One Williams Center
PO BOX 22186
Tulsa, OK 74172-2186

October 1, 2012

Re: Longhorn Pipeline Reversal – LMP Changes

East Houston to Crane 18" Pedernales River Basin

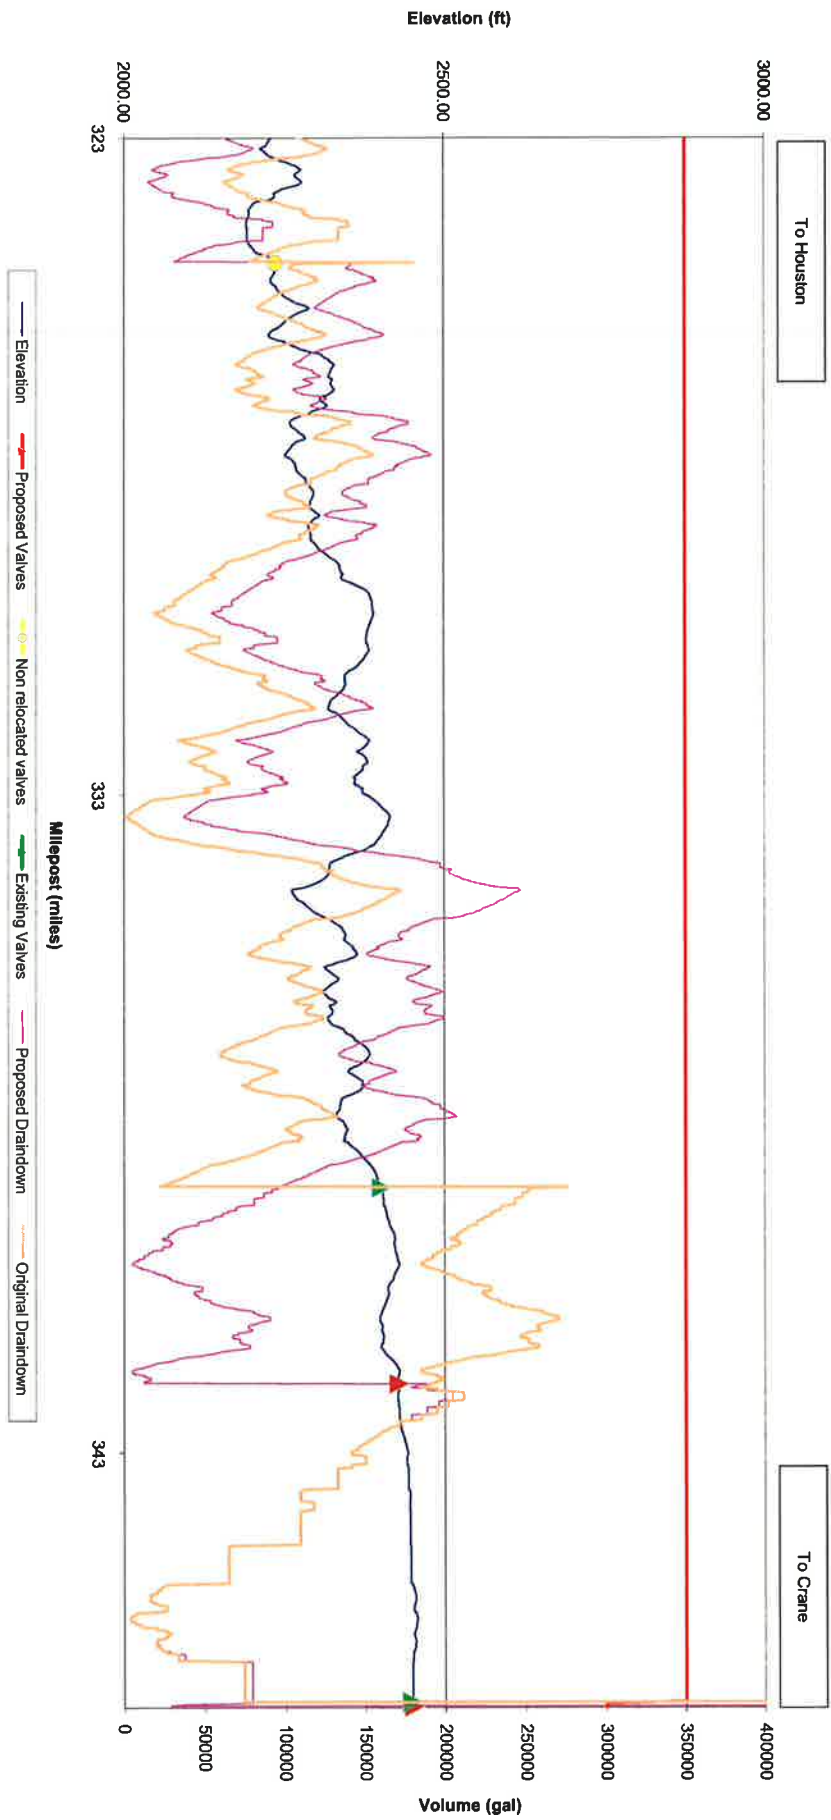
Location	Existing Max drain down (gal)	Proposed Max Drain down (gal)	Settlement Max Drain down (gal)
Between CV3 and CV10	103,657	84,365	200,000
Between CV10 and MP 198.64	114,141	109,178	200,000
Between MP 203.44 and CV6*	80,634	155,082	200,000
Between CV6 and CV7	55,830	132,750	200,000
Between CV7 and End of Basin	136,472	136,472	200,000

*Proposing to remove CV11 based on drain down profile

East Houston to Crane 18" San Saba River Basin

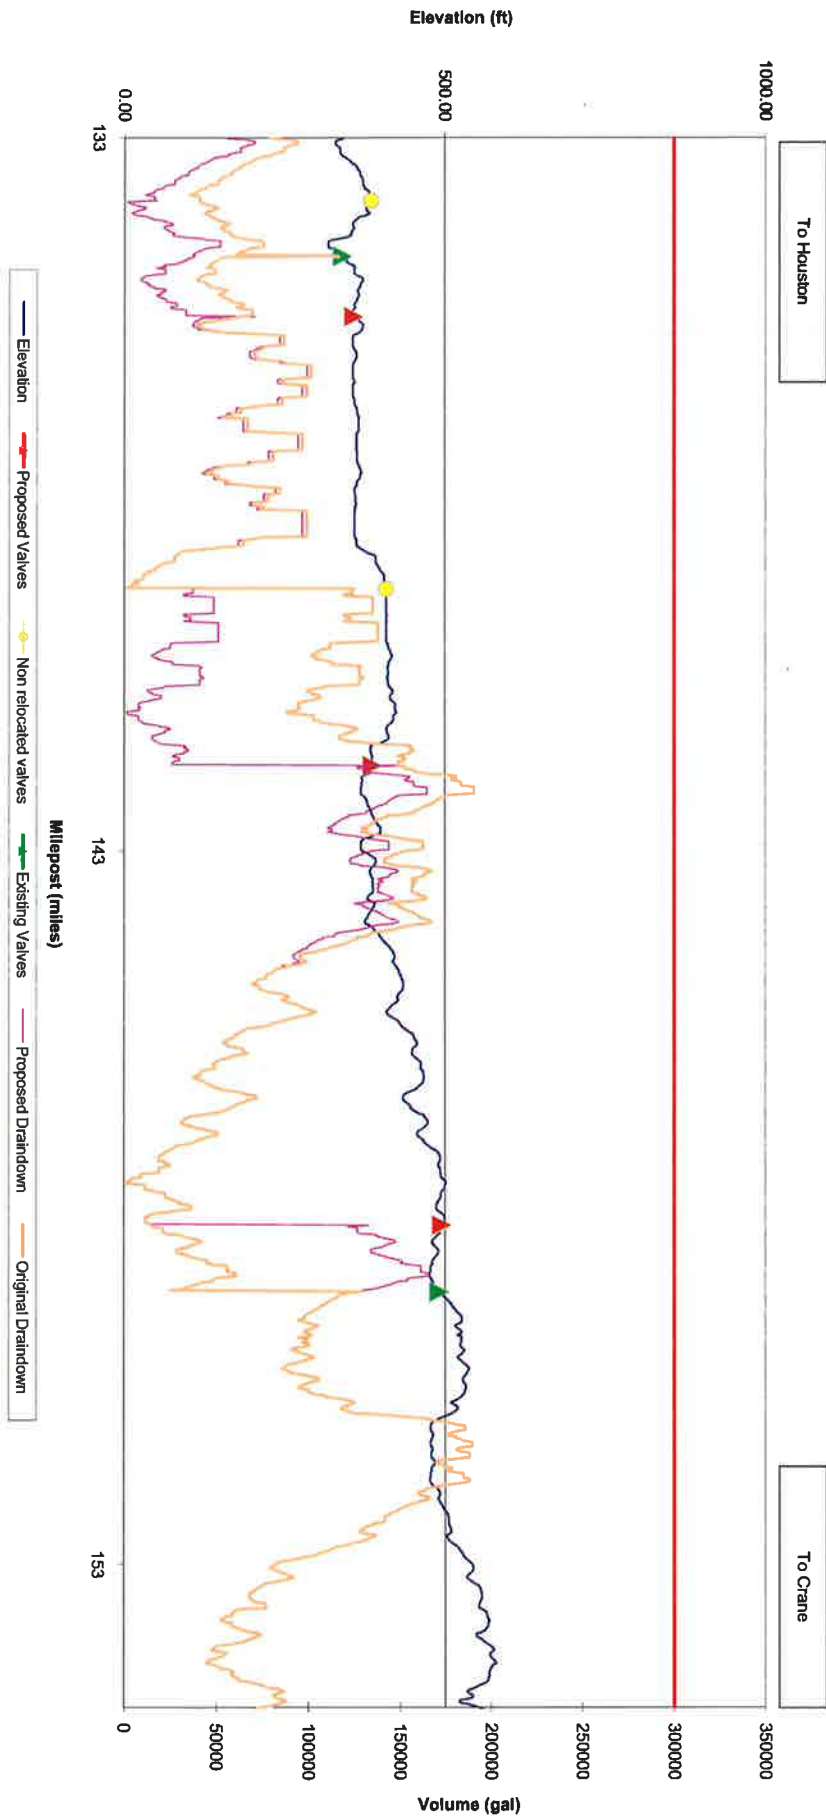
Location	Existing MP	Proposed MP		Settlement Max Drain down (gal)
		Previous	Current	
San Saba	Between MP 324.68 and CV15	181,136	246,981	350,000
	Between CV15 and CV16**	275,426	204,709	350,000

**CV 16 is at Edge of Basin, so no change west of this valve
